Bulletin No.: 23-NA-209

**Subject: Oil Can and/or Pop Noise from Roof Area During Car Wash**

Brand:	Model:	Model Year:		VIN:		Engine:	Transmission:
		from	to	from	to		
Chevrolet	Colorado	2023	2023	-	-	All	All
GMC	Canyon

6484170

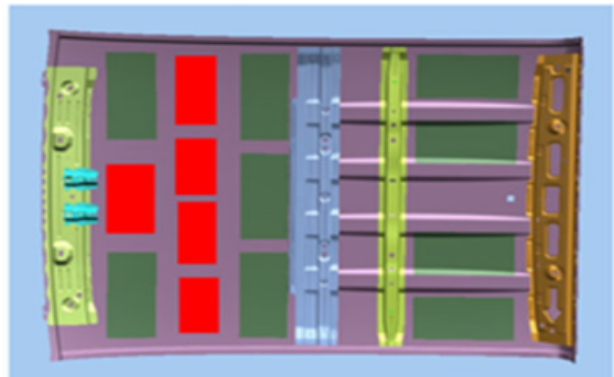
<b>Involved Region or Country</b>	North America
<b>Additional Options (RPOs)</b>	<b>Excluding</b> all vehicles equipped with Sunroof (RPO -CAC)
<b>Condition</b>	Some customers may comment on a oil canning or popping noise originating from the roof area during or after a automatic car wash.
<b>Cause</b>	The cause of the condition may be force from some air dryers at a automated car wash can cause flex in the roof panel, causing a loud oil canning type sound.
<b>Correction</b>	Repair any damage done during the event and apply stiffening patches to the underside of the roof panel following the procedure listed below.

- Once the headliner is dropped (but not removed) apply the 5 stiffening panels to the underside of the roof panel in the **RED** locations in the illustration above.
